**AGENDA FOR THE REGULAR MEETING OF THE
MIDWEST CITY**

PLANNING COMMISSION

October 6, 2020 – 7:00 p.m.

1. (PC – 2051) Discussion and consideration of approval of the proposed preliminary plat of The Curve, described as a part of the SW/4 of Section 8, T11N, R1W, located at 11004 SE 28th Street. This item was continued from September.

TREE CANOPY MANAGEMENT PLAN
PRE-DEVELOPMENT
1-101
SHEET NO. 1 OF 3
DATE: 08/21/20
PROJECT NO. 20607900

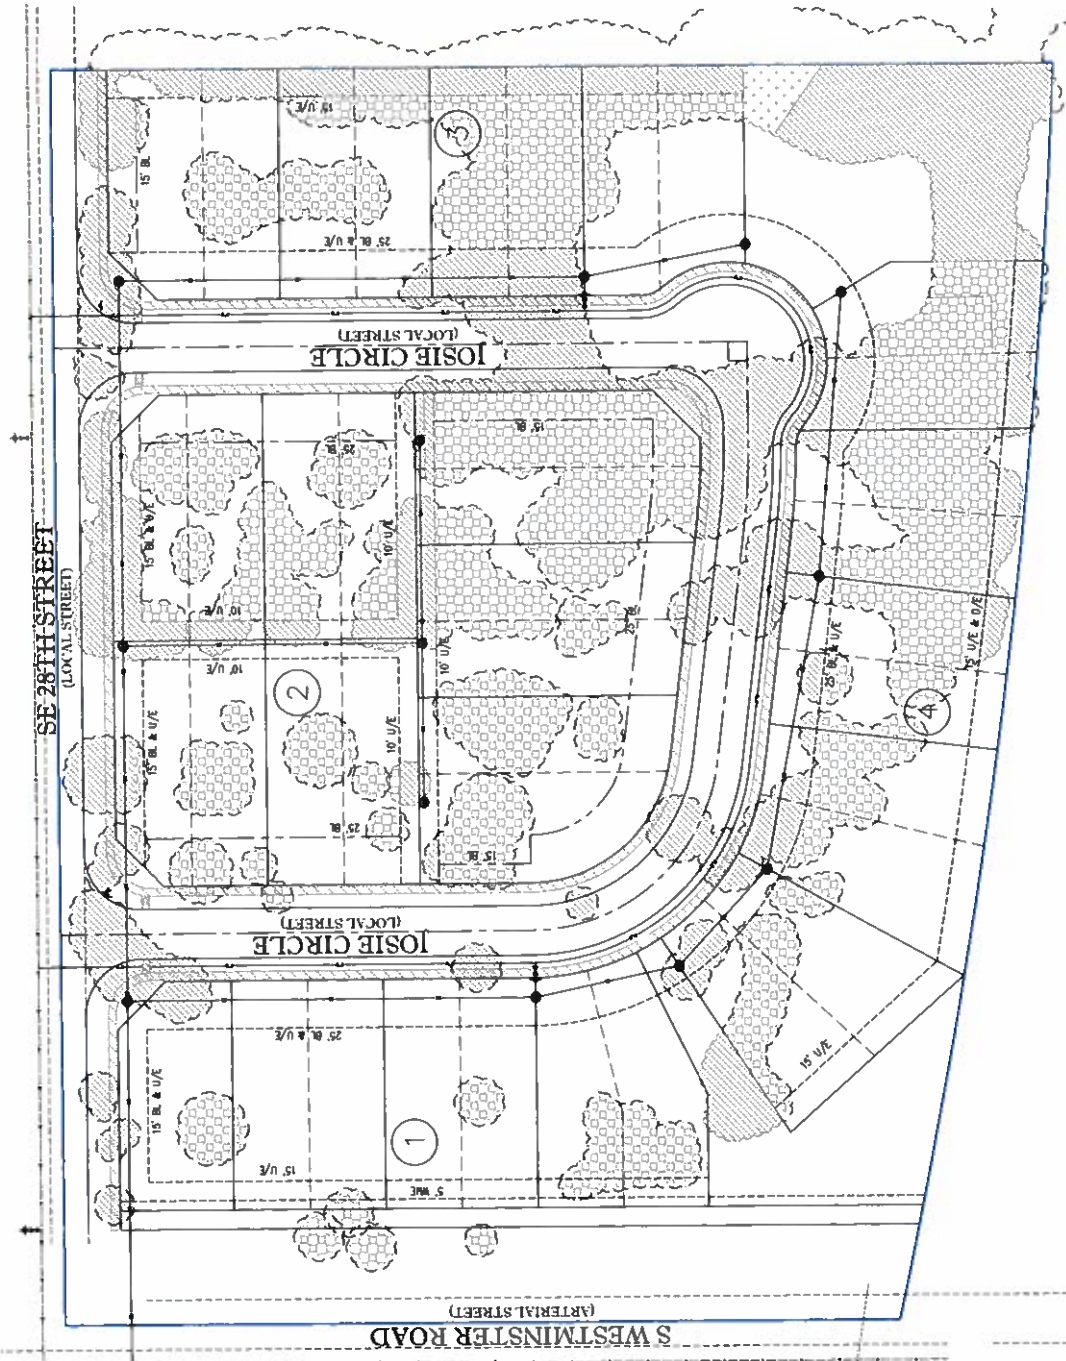
As required under section 38-53.4 of the 2012 Midwest City Subdivision Regulations, the applicant has prepared and submitted a Tree Canopy Management Plan. The applicant has chosen to pursue Option A which means that trees will be removed from areas dedicated for infrastructure such as utilities, drainage and the road. All other trees must remain throughout the platting process.

PRELIMINARY PLAN
 CITY OF WESTMINSTER
 TREE CANOPY MANAGEMENT PLAN
 POST-DEVELOPMENT
 L-102
 SHEET NO. 2 OF 3
 DATE: 06/21/20
 PROJECT NO. 20667900

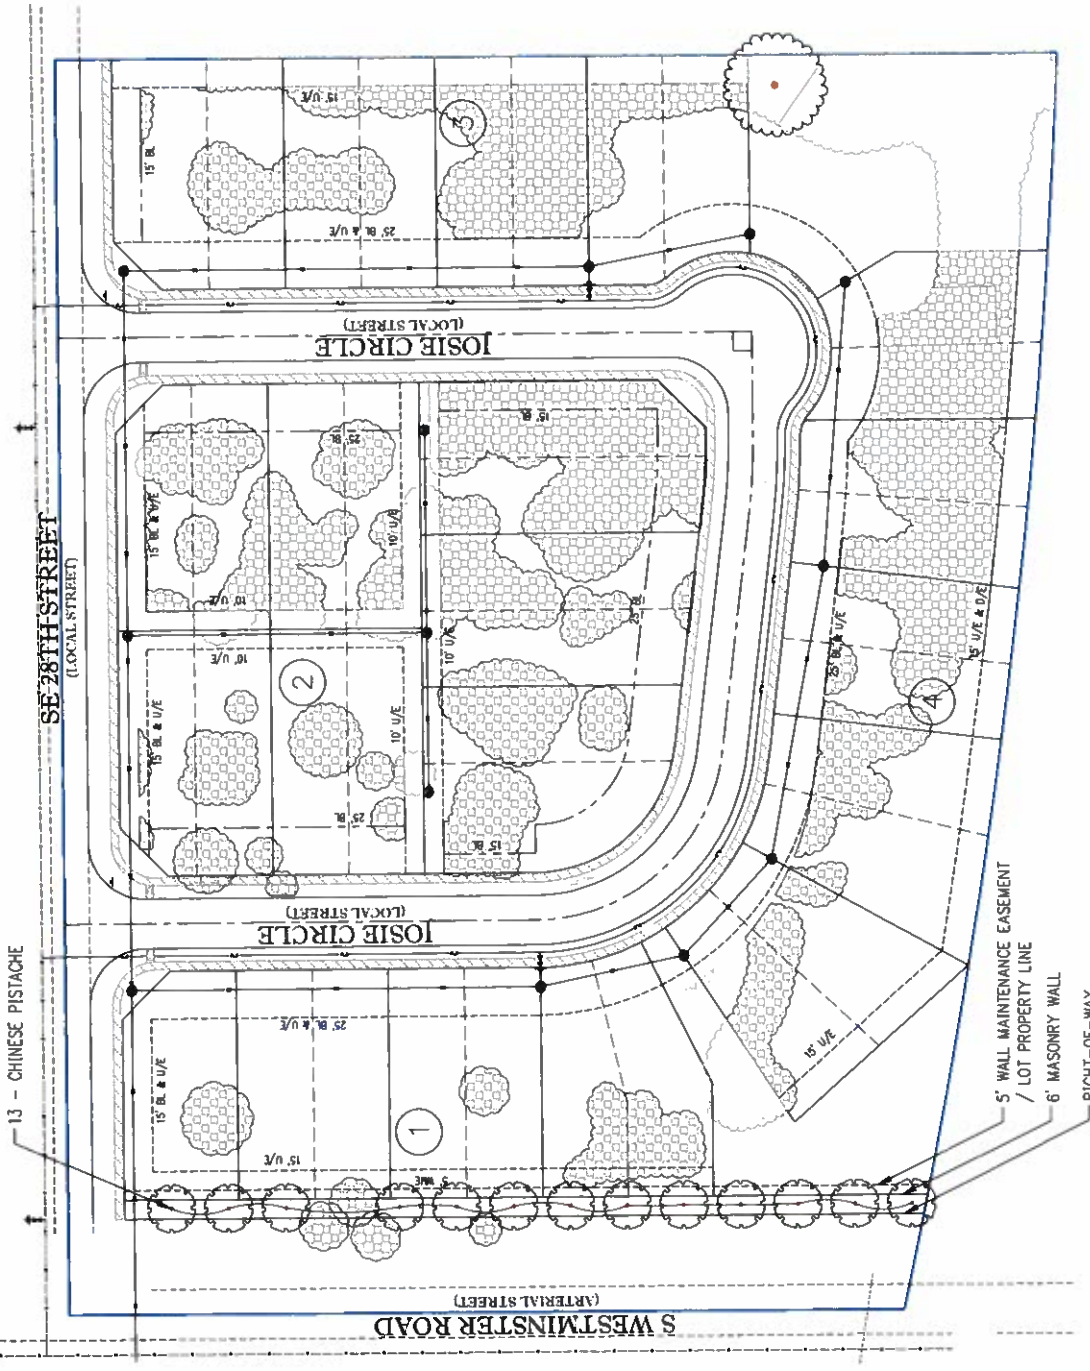
As the area of request has frontage on an arterial street, S. Westminster, Thoroughfare Screening is required by Section 38-46 of the Subdivision Regulations. The landscape plan shows a proposed 6' masonry wall along the back of the lots backing onto Westminster as well as landscaping of 13 Chinese Pistache trees.

PRELIMINARY PLANS
PRELIMINARY DRAINAGE PLAN

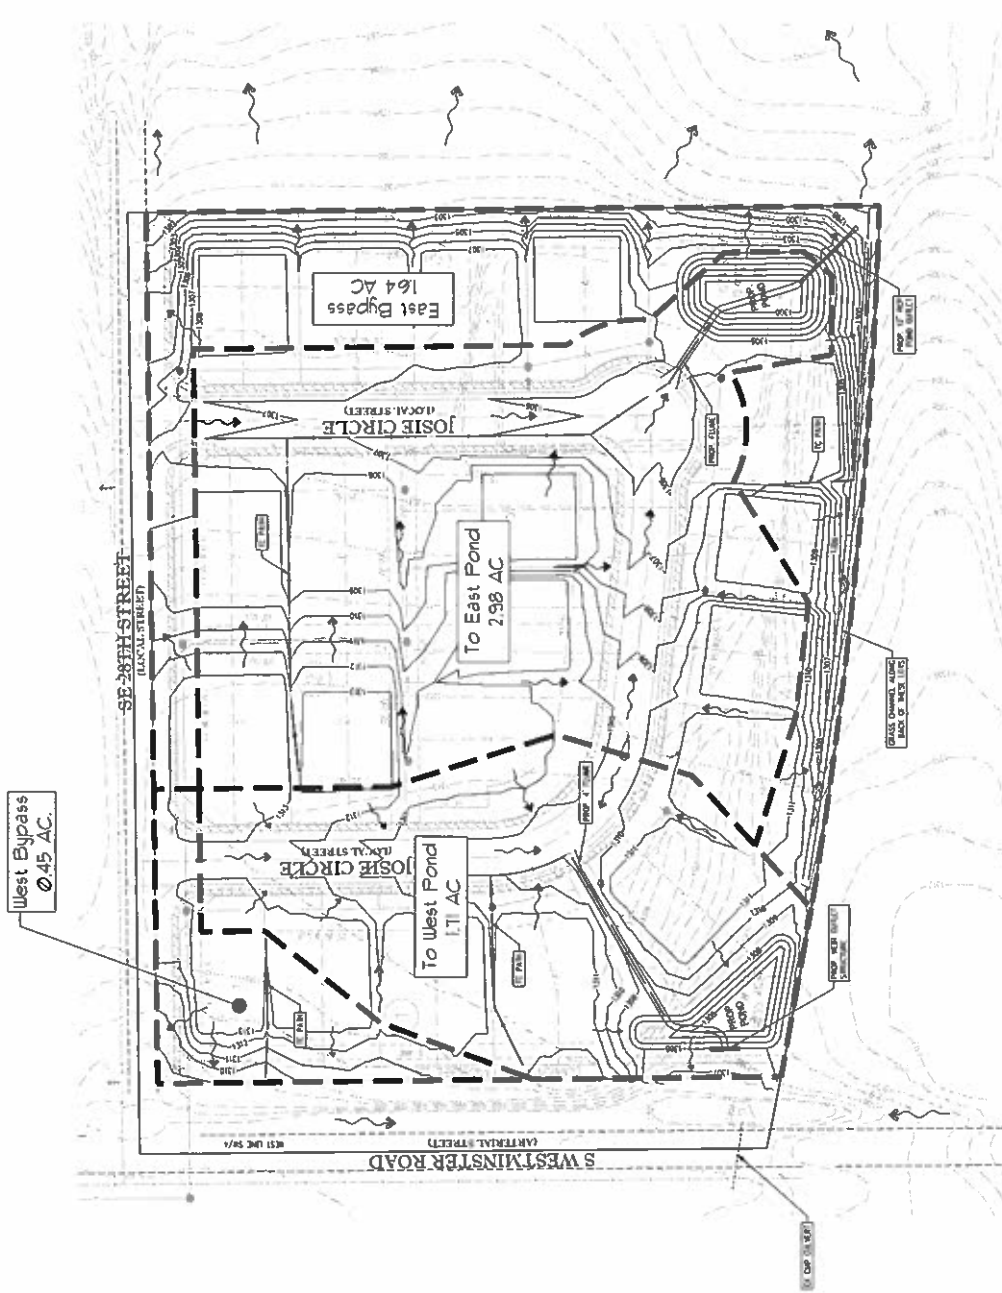
- A detention pond in the southwest portion serving Basin 1 would accept 1.71 acres (25% of the 6.77 total drainage acreage). The detention pond will outflow via a piped weir to the southwest corner of the property and onto Westminster Road right of way, just upstream of an existing cross drain. In construction plans we would ask that the development consider tying the systems together at a junction box.

- Bypass areas (31% of drainage acreage)
 - 0.45 acres are proposed to sheet flow directly onto Westminster Road right of way and into the city's existing ditch.

- 1.64 acres are proposed to sheet flow directly to the neighboring property to the east.
 - The back yards of 4 Lots will be flowing directly to the east. Sheet flow will be required.

- The back yards of 4 Lots on the south side are shown as bypass but via flowing across lots. This will not be allowed unless an improved (i.e. concrete) channel is provided for the lots to flow water across the lots. The end of improvement will need to have energy dissipation and allow for water to become distributed into more of a sheet flow.
